**Seattle  
Design  
Commission**

**MINUTES OF THE MEETING**

**20 September 2007 Project: Sound Transit University Link, Capitol Hill Station**

**Phase: 30% Design**

Capitol Hill Station Site Plan

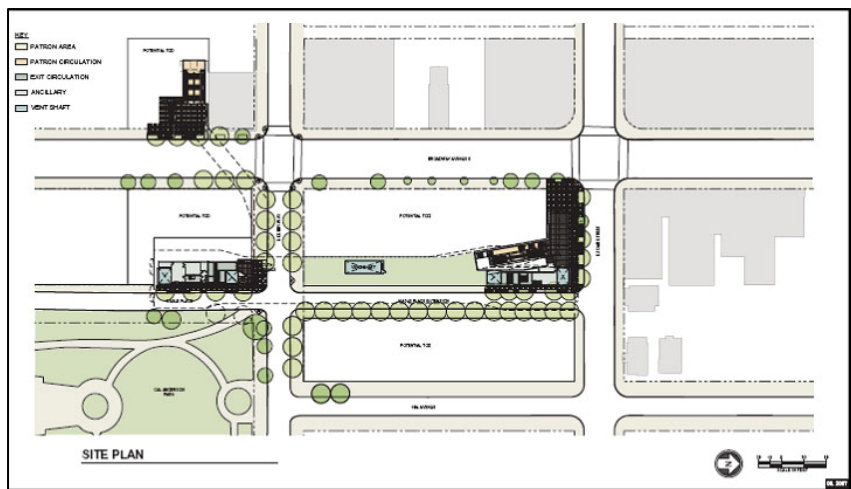
- **Approve and support the Nagle extension for a variety of functions with a focus on pedestrians.**
- **Support plans to engage an artist in the design and extend the art experience to both riders and pedestrians underground.**
- **Appreciate clarity of the design presentation and the color graphics.**
- **Support incorporation of natural light in structural elements such as vents and skylights in roof and would like to see this idea explored further, looking at both durability and maintenance.**
- **Appreciate differences expressed by each station entrance and the role of public architecture as a response to context.**
- **Underscore the importance of maintenance of glass and building canopies.**
- **Consider increasing size of the building at the West Entry.**

- Encourage attention be paid to wayfinding and information signage. Support addressing these functions in concert with architecture as the buildings themselves could also provide similar information.

- Like how Broadway retail wraps the corner at the North Entry.
- Revisit ways to bring light and openness to the South Entry and explore potential with Sound Transit for bringing natural light into the main tunnel vault.

- Encourage Sound Transit and SDOT to discuss the parameters for the adjacent TOD parcels, particularly their likely height and uses, in subsequent design work as this must inform the station design and vice versa.

- The “glowing box” at the east entrance should be more subtle to relate better to the park.
  - There will be a green wall on that side.
- The vent shaft on the south entrance is not a good location. It is opaque and blocks light from entering the stairwell.
